CHICAGO TRANSIT AUTHORITY
Advertisement for Bids

Notice of Time Extension and Addendum No.1

Req No.: C23FI102850510,
Invitation for Bids (IFB) for Construction Services for All
Station Accessibility Program (ASAP) Lake Line - Austin
Station.

Subject: C23FI102850510 – Invitation for Bids (IFB) for Construction Services for
All Station Accessibility Program (ASAP) Lake Line – Austin Station

AUS-109(REV)

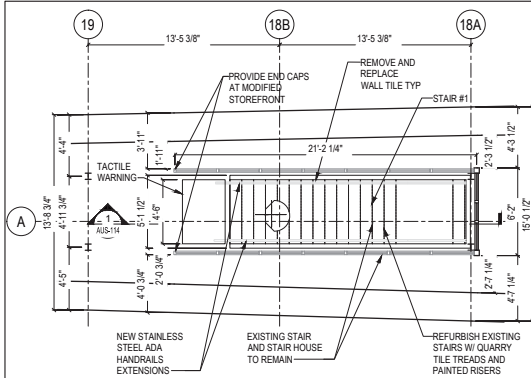
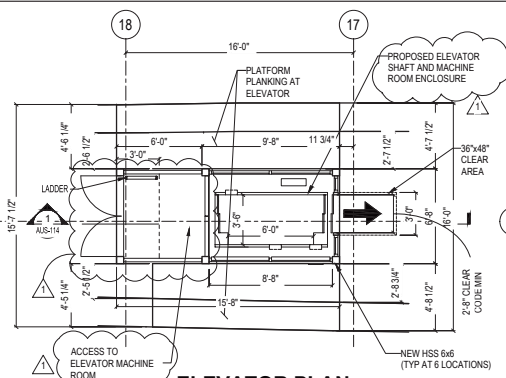
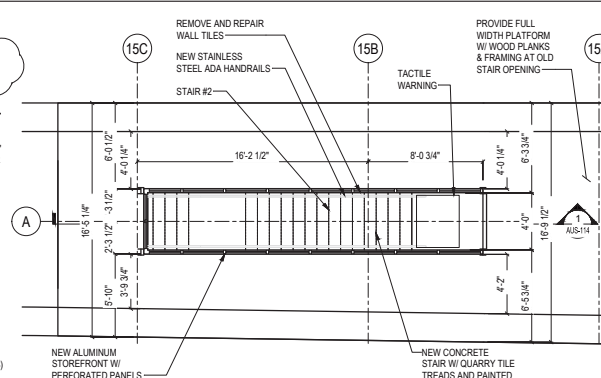
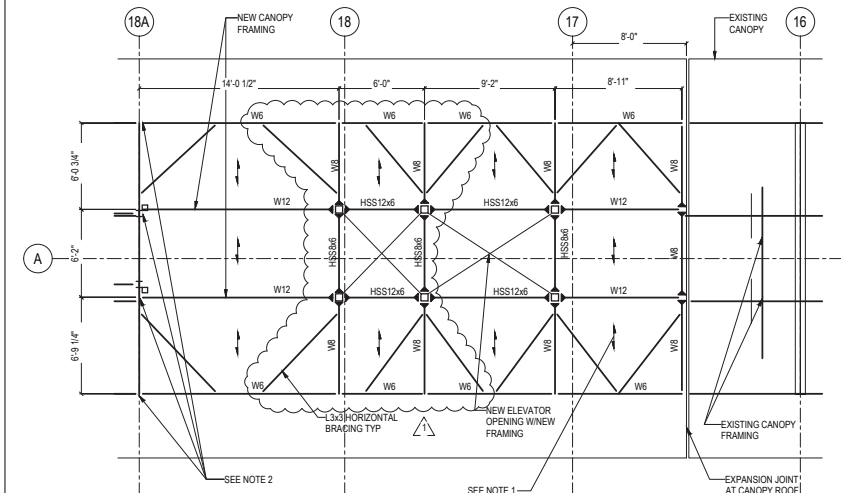
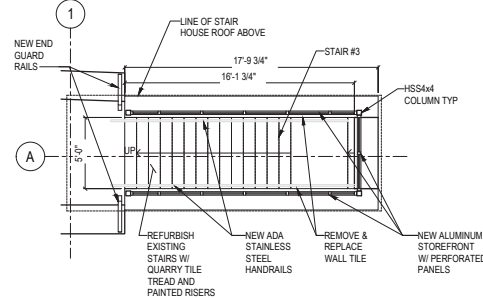
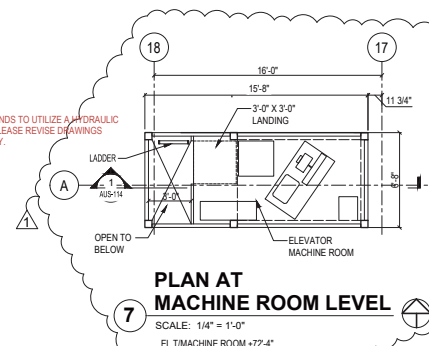
NOTE:
1. NEW ROOF DECK TO MATCH EXISTING.
2. CONNECT NEW BEAM TO EXISTING STRUCTURAL MEMBER (COLUMN OR BEAM).
3. THE CTA INTENDS TO UTILIZE A HYDRAULIC ELEVATOR, PLEASE REVISE DRAWINGS ACCORDINGLY.

NOTE: THE CTA INTENDS TO UTILIZE A HYDRAULIC ELEVATOR, PLEASE REVISE DRAWINGS ACCORDINGLY.

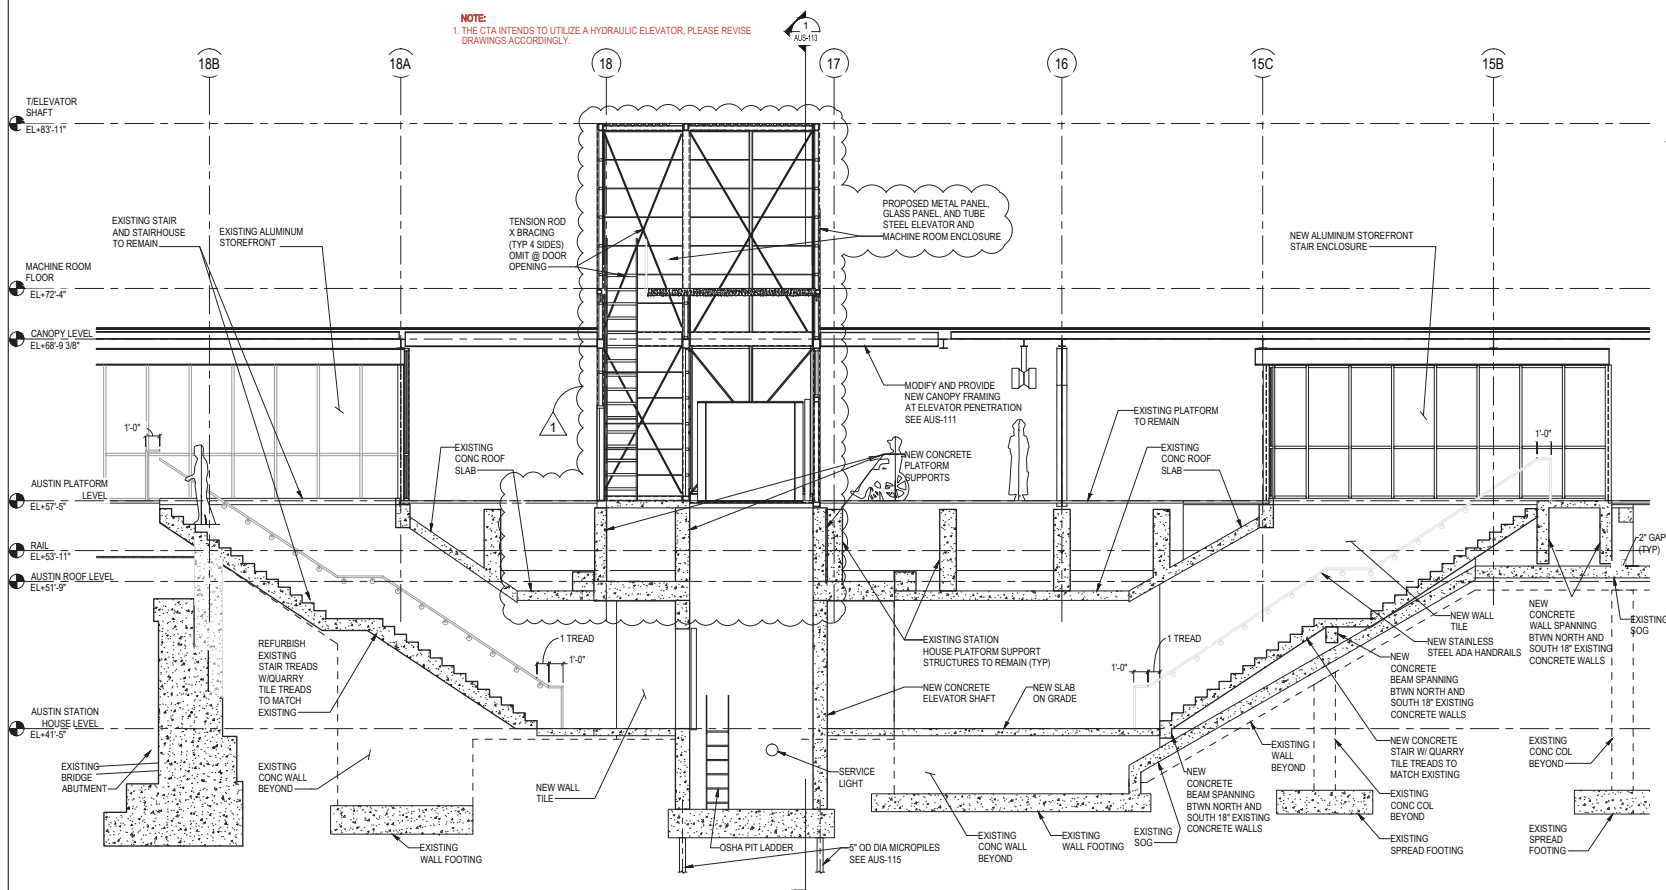
NOTE:
1. THE CTA INTENDS TO UTILIZE A HYDRAULIC ELEVATOR, PLEASE REVISE DRAWINGS ACCORDINGLY.

1. PROVIDE HEAVY DUTY ~~TRANSIT TRACTION~~ POWER ELEVATOR MACHINE ROOM PER ASME. THE ELEVATOR SHAFT ABOVE THE ELEVATOR MACHINE EQUIPMENT SHALL NOT BE LOCATED IN THE PIT.

2. PROVIDE NEW ELEVATOR TOWER WITH PIT.
3. ~~DESIGN OF THE ELEVATOR EQUIPMENT FOR A 150 LB CAPACITY.~~
4. DESIGN OF THE ELEVATOR SHALL PROVIDE A MINIMUM SPEED OF 200 FEET PER MINUTE (FPM).
